To: T10 Technical Committee
From: Rob Elliott, HP (elliott@hp.com)
Date: 6 December 2007
Subject: 08-009r0 SAS-2 Elasticity buffer clarifications

This proposal clarifies issues regarding deletable primitives and the elasticity buffer.

Figure 36 — Receive data path in a SAS phy

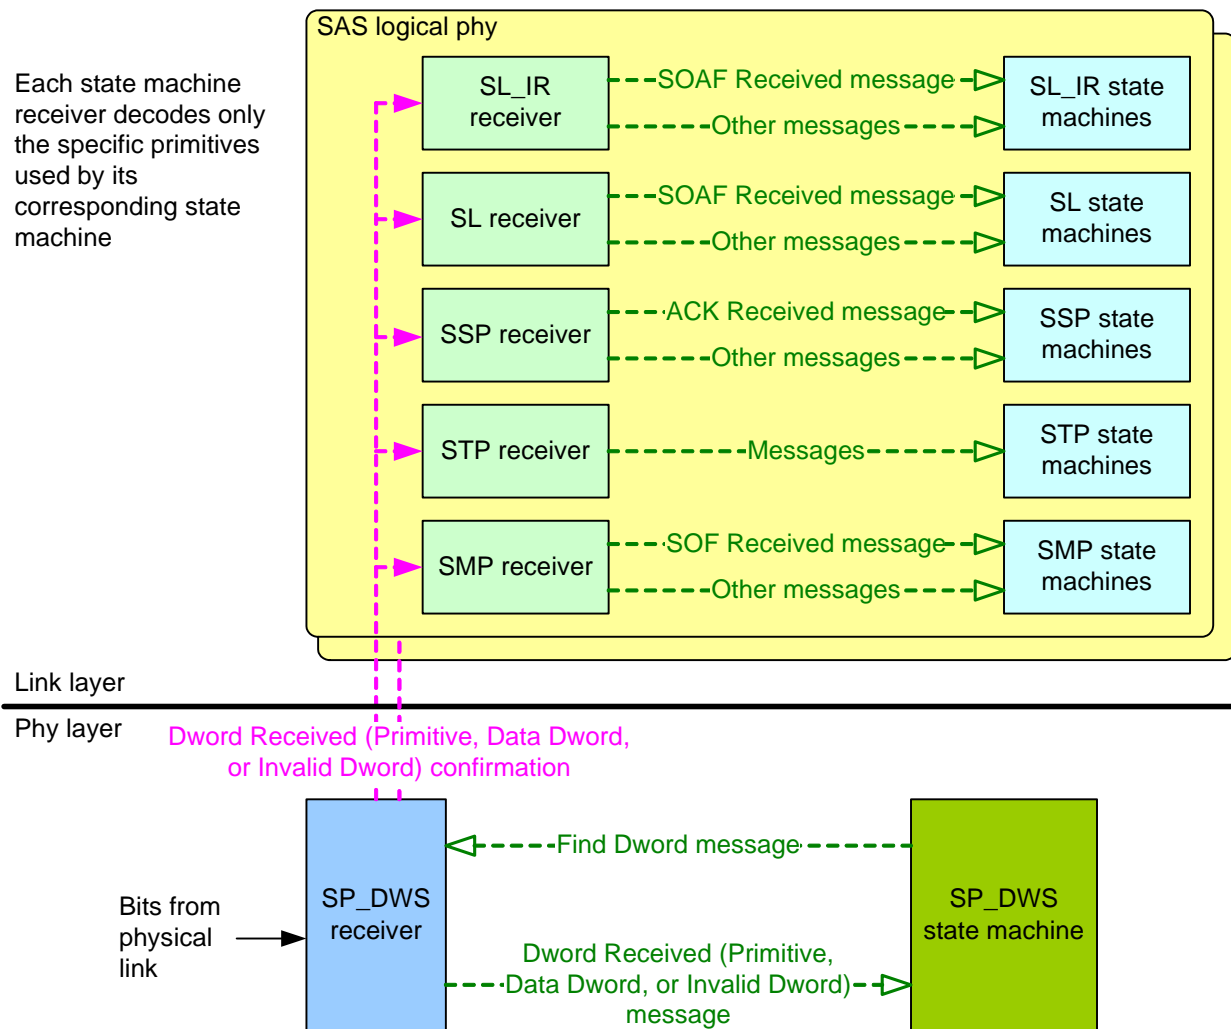
See figure 156 in 7.3.1 for more information about the elasticity buffer, which is not shown in figure 36.

Figure 37 — Receive data path in an expander phy

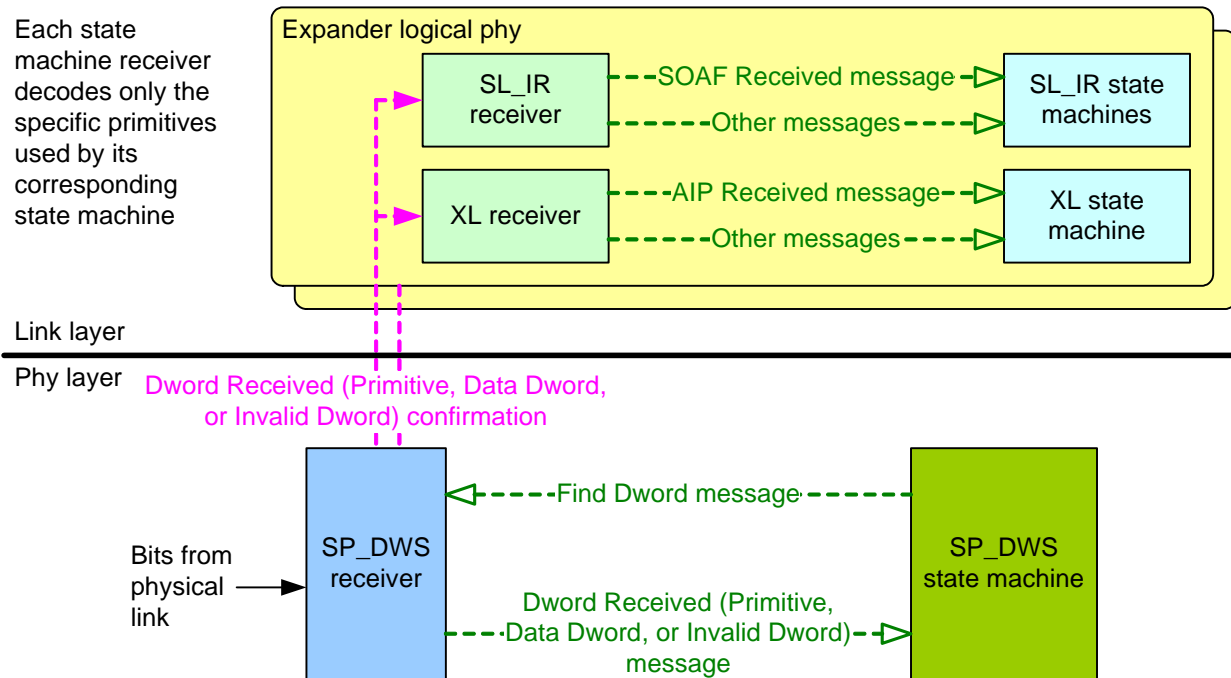
See figure 156 in 7.3.1 for more information about the elasticity buffer, which is not shown in figure 37.

Figure 156 — Elasticity buffers

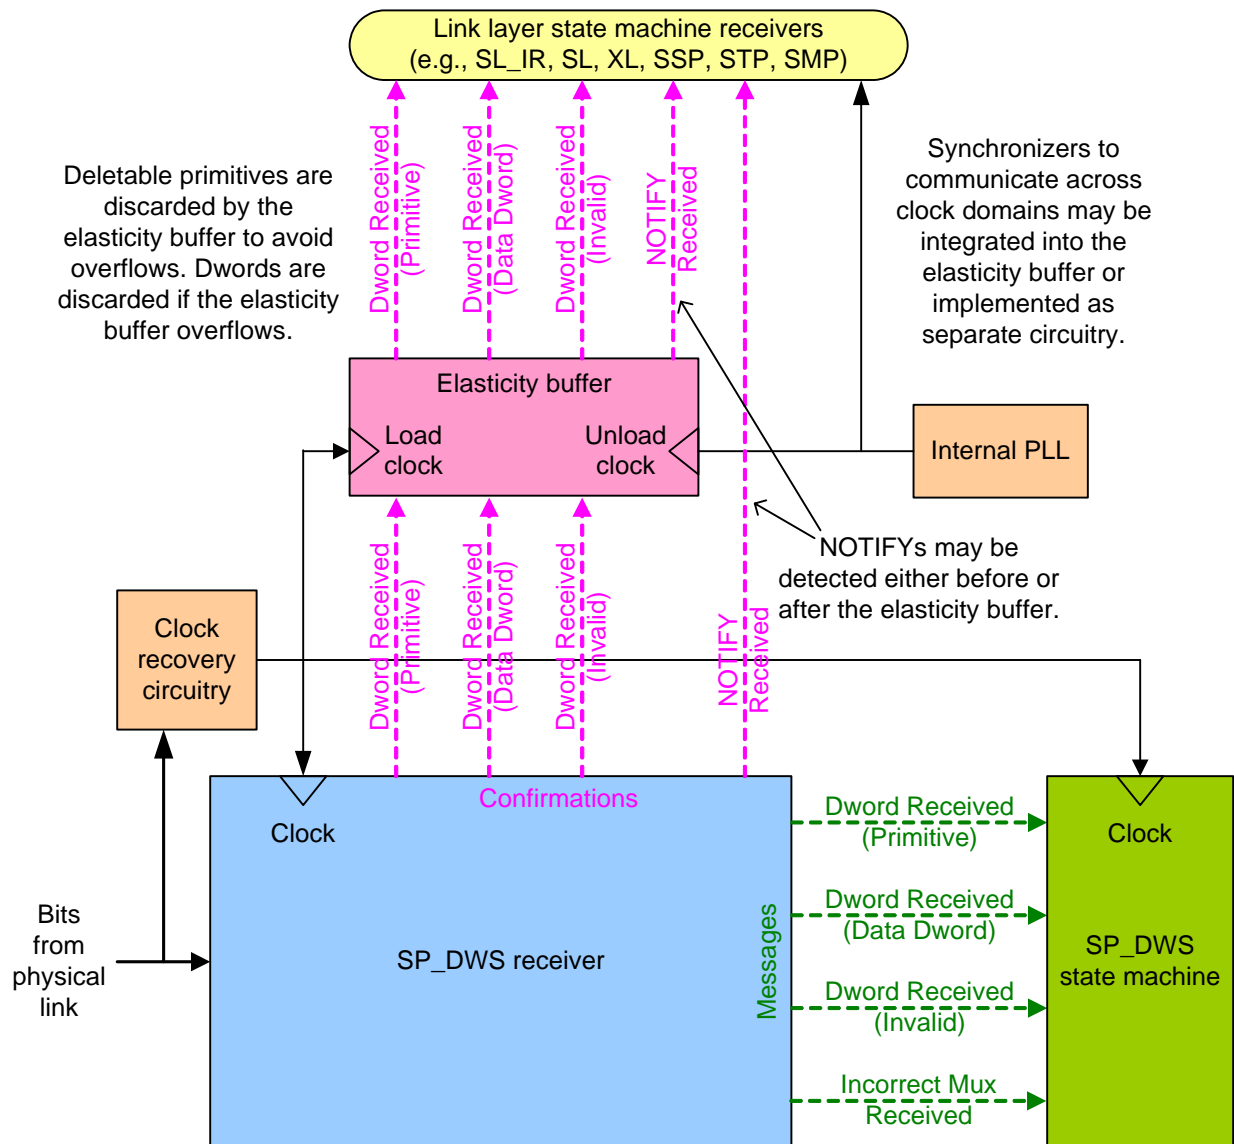
1. Based on feedback from a SAS-2 editing session, the elasticity buffer figure is redrawn to show more detail about how the elasticity buffer interacts of the state machines.

Elasticity buffer circuitry, as shown in figure 156, is required to absorb the slight differences in frequencies between the phys. The frequency tolerance for a phy is specified in 5.3.3. The depth of the elasticity buffer is vendor-specific but shall accommodate the physical link rate tolerance management deletable primitive insertion requirements in table 119 ([see 7.3.2](#)).
